# Emissions Recall

**Subject:** Fuel Tank Breather Hose Replacement

**Bulletin:** R0029

**Campaign #:** A6230

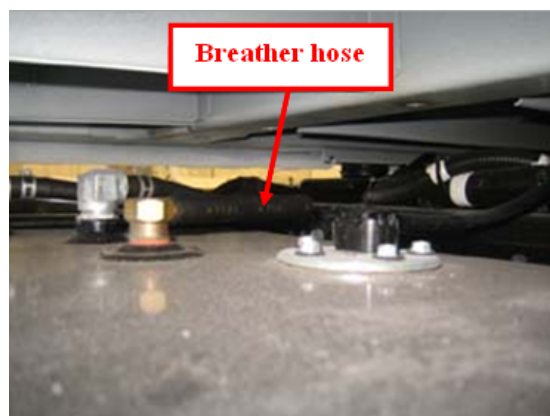
The fuel tank breather hose(s) has been modified to prevent water from entering into the fuel tank(s).

2. Remove the fuel tank breather hose.

3. Install the new breather hose onto the fuel tank.
